Docket Number:	12-AFC-02
Project Title:	Huntington Beach Energy Project
TN #:	202913
Document Title:	City of HB â€™ Comments on fire road/landscaping plan
Description:	N/A
Filer:	April Dearbaugh
Organization:	California Energy Commission / David Flores
Submitter Role:	Commission Staff
Submission Date:	8/13/2014 10:16:58 AM
Docketed Date:	8/13/2014

From: Flores, David@Energy
Sent: Monday, August 11, 2014 10:23 AM
To: Miller, Felicia@Energy
Subject: City of Huntington Beach Comments regarding FSA for HBEP

Huntington Beach Energy Project - Conceptual Image of Fire Department Requirements for Landscape Plantings along the Fire Road

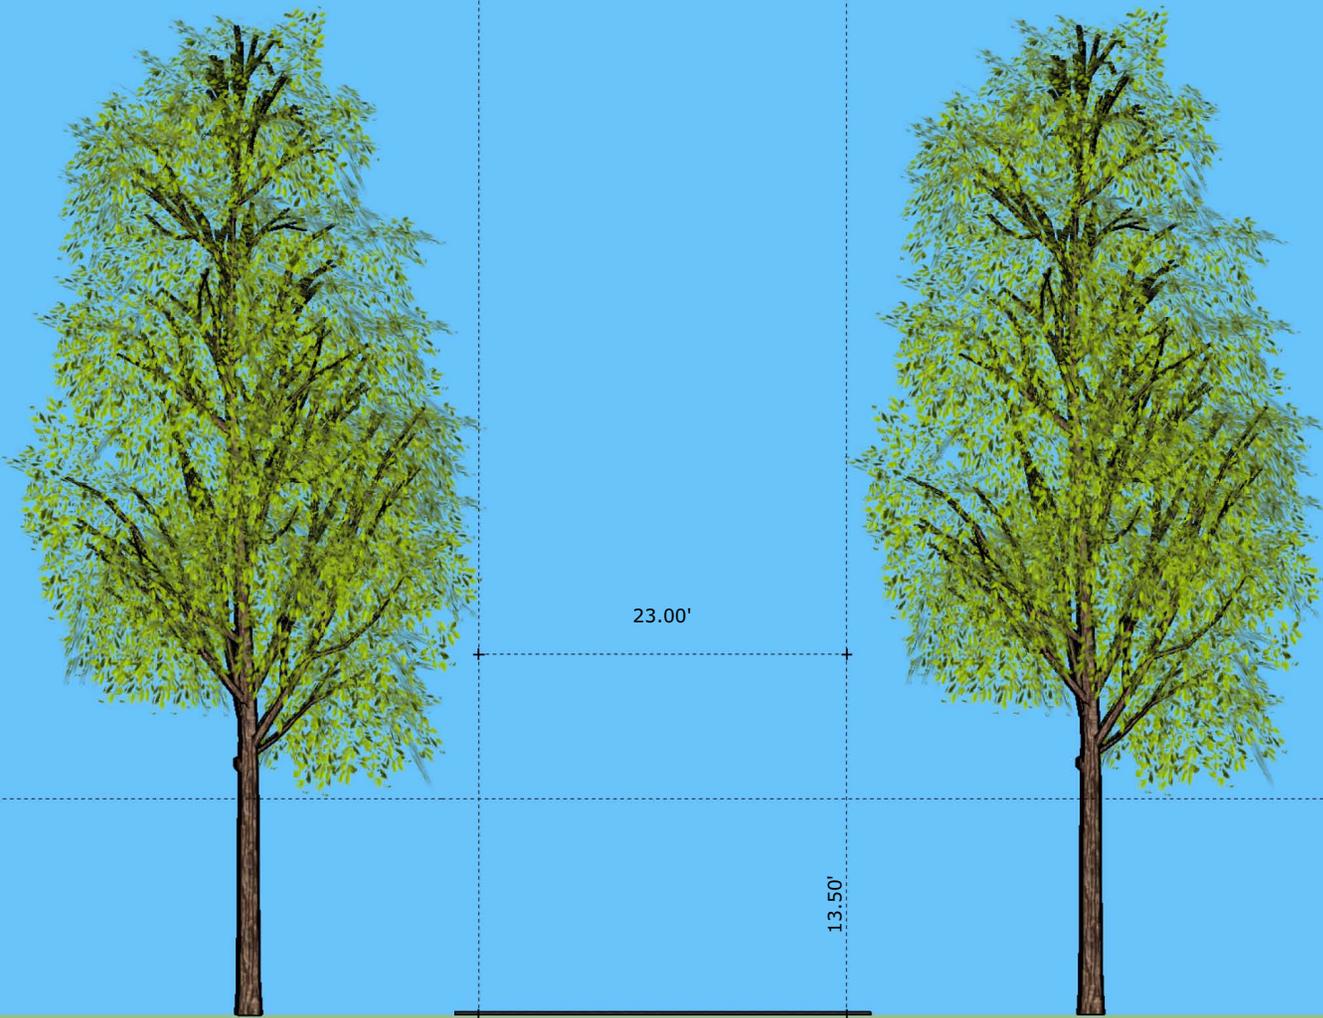
Staff prepared a conceptual drawing (attached) to show HBFD's requirements to avoid encroachments on the fire road (see #3 in the HBFD's comments below).

3. Some of the 34 California Fan Palms are immediately adjacent to the fire access road. Fire Access roads in Huntington Beach are typically required to be kept clear to the sky to facilitate Fire Department Access. However, 1 1/2' on each side of the 26' wide fire road can have above encroachments that are maintained at 13 1/2' minimum.
